# La Marzocco Technical Bulletin #108

## Barista Light Kits

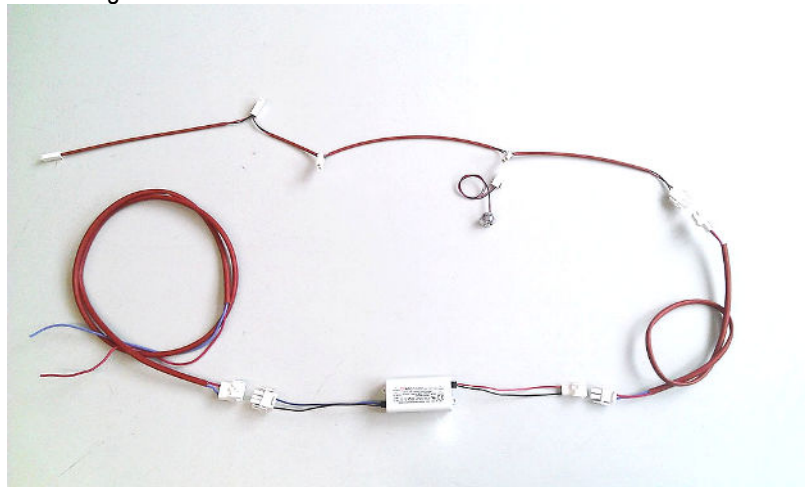
We are pleased to inform you about the introduction of a new barista light kit, which includes a new transformer and wiring system.

All cables are equipped with new connectors, making new installations or replacing single sections easier. When updating from the old transformer to new transformer, it may be necessary for technicians remove the previous wire connector and in its place use:

E.4.081	Female connector pin
E.4.062	Male connector pin
E.4.080	Female connector
E.4.057	Male connector
